Requests to be Heard

Planning and Amenity

Delegated Committee Meeting

14 February 2022 Planning and Amenity Delegated Committee Meeting

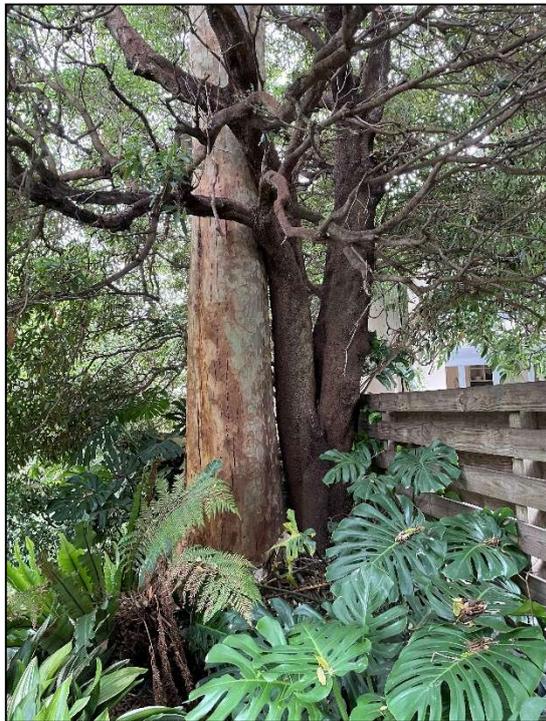
- These particular site characteristics serve to significantly impact on the space and opportunities available for the construction of a new dwelling on the property.
- Tree 12 has been identified in the Arboricultural Report accompanying the application prepared by TMC Reports, Arboricultural Consulting Services, as having a Fair/Poor structure, and being of Low Amenity Value and Low Retention Value. Additional photos of this tree are included below for your reference.

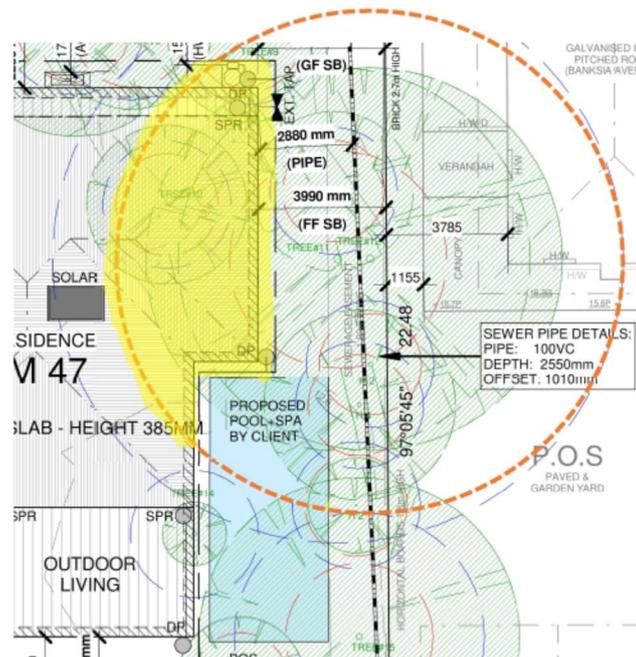
- The tree is located toward the rear northern boundary, within the existing easement and directly on top of the existing sewer pipe. Accordingly, the tree is not appropriately sited and could be causing damage to the existing sewer infrastructure by its roots.
- We note that the Sweet Pittosporum species is identified on Page 63 of Council's "Live Bayside Plant Bayside" document (<https://www.bayside.vic.gov.au/sites/default/files/2021-09/Live%20Bayside%20plant%20Bayside.pdf>) as being a "Pest Plant". Pest Plants are described as –
 - *When a plant thrives and invades an area where they do not naturally occur they are known as a pest plant, weed or invasive species.*
 - *Seeds and cuttings can be carried many kilometres by wind, water, tools, vehicles, clothing, pets, birds and animals. Plants can spread from people dumping garden cuttings in reserves and waterways.*
